Access Compliance Report

Public Rights-of-Way

Intersection ID: 10011027	Main Street: BLACKHAWK_RD	Cross Street: N/A	Location: S
ADA ID: E54B1683D276	Ramp Type: Perp	Initial Pass/Fail: Pass	Overall Compliance: No
Codes/Mitigation Info/Possible Solution		Field Measurements/Component Compliance

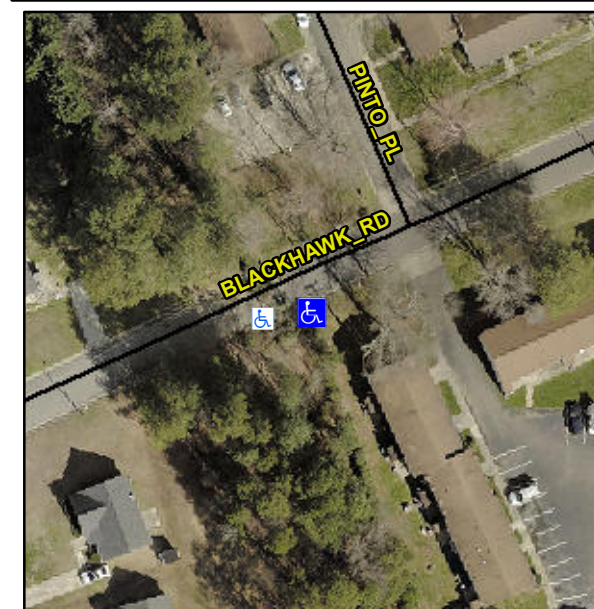
**Not Found, R304.5.3, R304.2.2-Perp,
R304.3.2-Para, R305, R302.7.2,
R304.5.4**

Compliance	Description	Data	Compliance	Description	Data
N/A	Ramp Length (in)	46.5	Yes	Ramp Slope (%)	5.4
Yes	Ramp Width (in)	73.0	No	Ramp XSlope (%)	3.5
N/A	Flare Type LT	None	N/A	Flare Type RT	N/A
N/A	Flare Slope LT (%)	N/A	N/A	Flare Slope RT (%)	N/A
N/A	Flare Traversable LT?	N/A	N/A	Flare Traversable RT?	N/A
Yes	Landing Length (in)	58.0	No	DWS Provided?	No
Yes	Landing Width (in)	71.0	N/A	DWS Contrast?	No
No	Landing Slope (%)	2.6	N/A	DWS Length (in)	N/A
Yes	Landing X Slope (%)	1.7	N/A	DWS Full Width?	No
N/A	Landing Curb? (Y/N)	No	N/A	DWS Offset (in)	N/A
N/A	Shared Landing?	No			
Yes	Gutter Ponding?	No	No	Gutter Slope (%)	6.0
No	Gutter Lip Ht (in)	1.0	Yes	Gutter X Slope (%)	0.2
N/A	Painted X Walk1?	No	N/A	Painted X Walk2?	N/A
	X Walk 1 Direction	To N		X Walk 2 Direction	N/A
N/A	X Walk 1 Width (in)	N/A	N/A	X Walk 2 Width (in)	N/A
	X Walk 1 Slope (%)	6.3		X Walk 2 Slope (%)	N/A
	X Walk 1 X Slope (%)	0.9		X Walk 2 X Slope (%)	N/A

**Remove & Replace Entire Ramp.
Remove & Replace Gutter.**
